Docket Item # 4  
BAR CASE #2010-0293

BAR Meeting  
April 6, 2011

**ISSUE:** Signage  
**APPLICANT:** Capital One Bank  
**LOCATION:** 500 South Washington Street  
**ZONE:** CD/Commercial

Figure 6: Previous and proposed ATM header sign – Wilkes Street walk up.

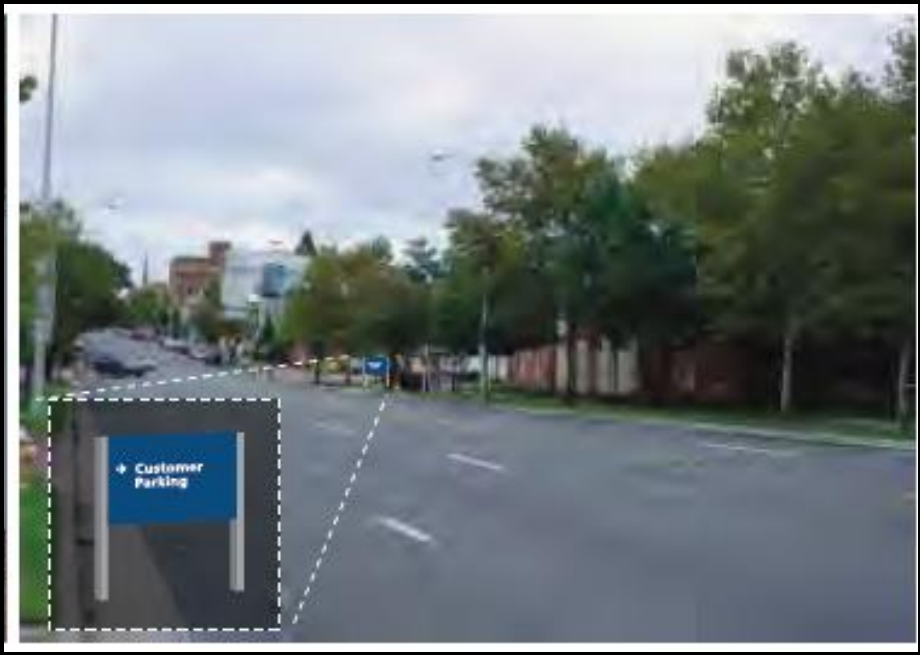
- The header sign on the walk up ATM on the Wilkes Street elevation of the bank will be reduced in size and not illuminated. Again, illumination will be limited to the ATM machine itself.

Figure 9: Proposed customer parking sign on bank property (3).

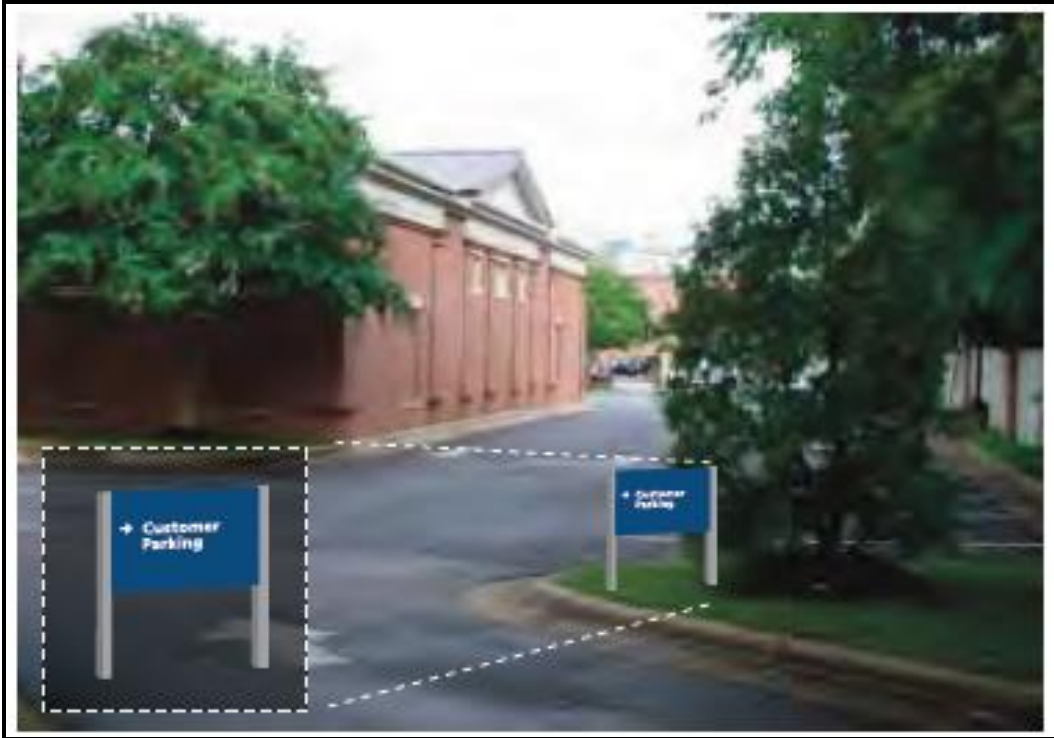
Staff encouraged the applicant to remove the numerous "customer parking" signs located at nearly every parking space within the bank's parking lot, and instead encouraged a sign at each of the Bank's two entrances, as recommended by Mr. Carlin at the previous hearing. Instead, the applicant proposes four monument-style customer parking signs – two on Washington Street and two within the property. The application is somewhat confusing as to where the actual signs will be located, although Staff believes from the mock-up photographs that the Washington Street signs may be located in the public right-of-way, which is not permitted. In the opinion of Staff, the two customer parking signs within the bank property are unnecessary and redundant. Instead, Staff recommends the installation of a customer parking sign at the Washington Street parking entrance and another at the Wilkes Street entrance, provided they are located on the bank's property. An alternative to the freestanding signs may be the installation of signs on the low brick wall which surrounding the bank's parking lot.

Figure 13: Photo of existing illuminated walk-up ATM.

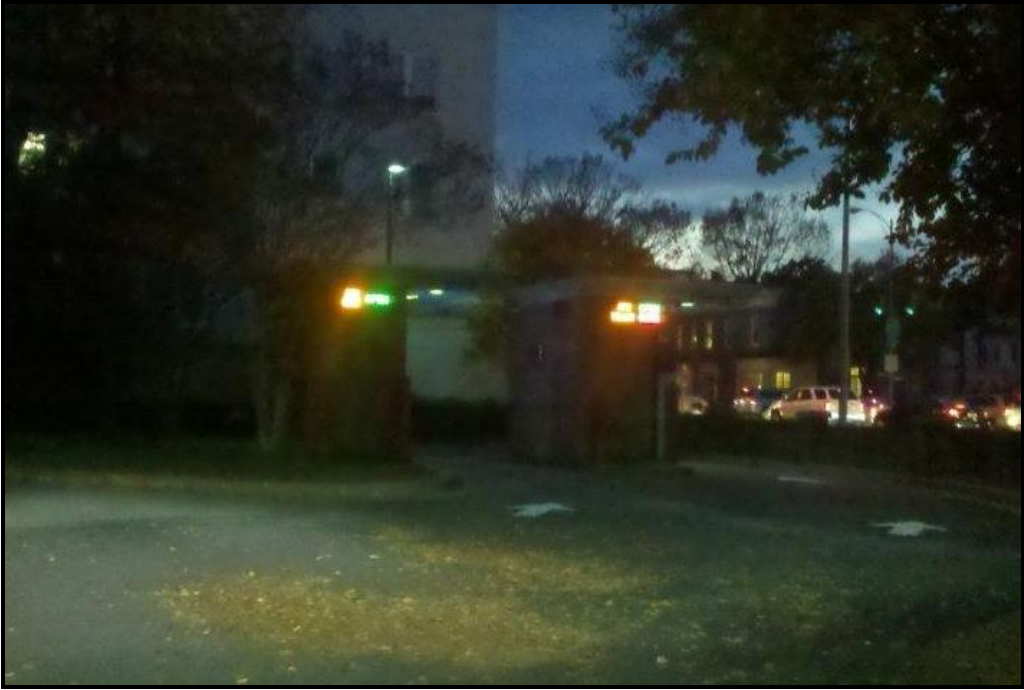
When the Board originally approved the bank building in the mid-1990s, they approved the ATMs with "other signage normally associated with ATMs." As a result, Chevy Chase Bank installed illuminated header and side panels on each of their three ATMs, as well as "ATM/Teller open/closed" neon-like LED signs on each drive-thru ATM kiosk. At the January BAR hearing, the Board expressed concern about the amount of illumination associated with each of the bank's three ATM machines. Capital One Bank no longer proposes to use the built in internal illumination for the header and side panels of the ATMs, and the only illumination will be for the machines, which is essential for customer safety. Staff does not object to the use of the bank's logo on the ATM header signs, especially the Wilkes Street walk up machine, which will have a much smaller sign than currently exists.
